- Subject:** Engine extension/retraction drive.
- Applicability:** DG-400's works numbers 4-1 to 4-188.
- Priority:** Procedure 1, 2 must be executed immediately.  
Procedure 3, 4 must be executed within 90 days.

Instructions for the modification of the spindle drive

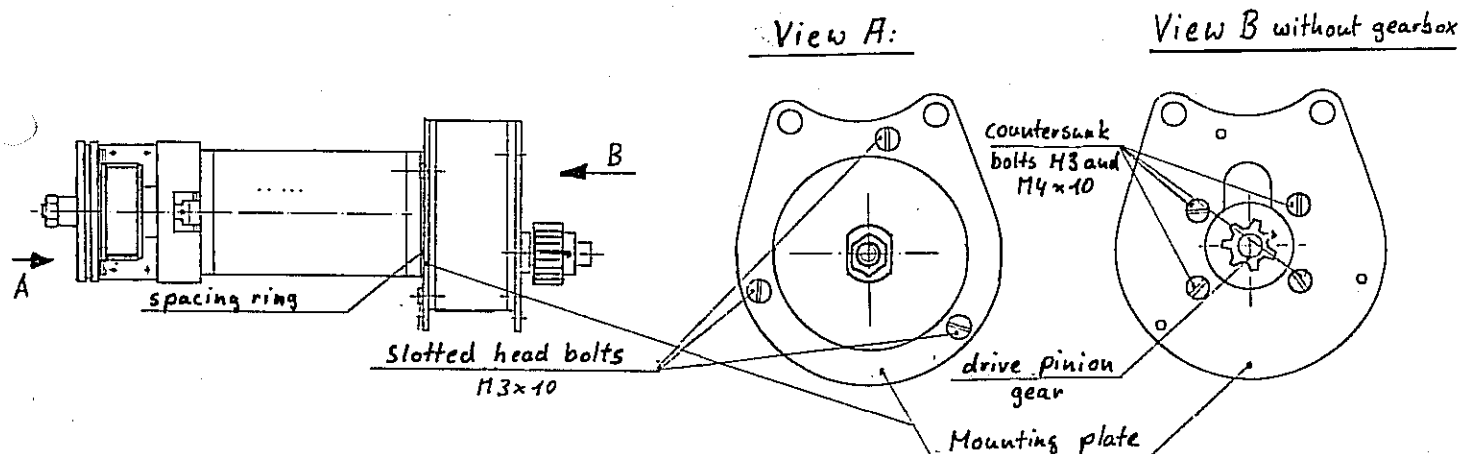
- Procedure 4:** Modification of the spindle-drive.  
The mounting plate between the spindle motor and the gearbox has to be replaced in order to reduce the amount of free-play between the drive gear and the gearbox.

a) Removal of the drive motor

1. Extend the engine fully. Cut and remove the rubber cord attached to the forward engine doors.

Remove the canopy, and in order to secure the engine, tie a rope of at least 4 mm in diameter between the centre of the propeller and the canopy hinge.

2. Remove the large brass gear wheel (4R12) by bending the tab-washer (A 30 DIN 70952 St) back carefully with a screwdriver and undo the slotted nut (M 30 x 1,5) with a crescent wrench (45/50).
3. Lift the gear wheel carefully using a rubber hammer.
4. Remove the two M 60 x 50 bolts that attach the drive motor mechanism and disconnect all of the wiring connected to the motor. The electrical connectors are located on the cover of the flap operating lever on the left hand side of the engine compartment, and in order to disconnect them the heat-shrink tubing must be cut off.

b) Disassembly of the drive motor and replacement of the separator plate

1. Remove the three slotted-head bolts (M3) on the underside of the separator plate and then remove the gearbox.

2. Unscrew the four countersunk bolts (two are M3 and two are M4) in order to remove the old mounting plate from the spindle motor. The old mounting plate and the spacing ring can be discarded as they are no longer required.

3. Check the motor's exposed drive gears for signs of damage (broken teeth, excessive wear etc.). If the gears are damaged, a replacement motor can be obtained from Glaser-Dirks.
4. The new mounting plate is reassembled using three round head bolts (M 3 x 10 DIN 964 Stzn) instead of the slotted-head bolts (M 3).
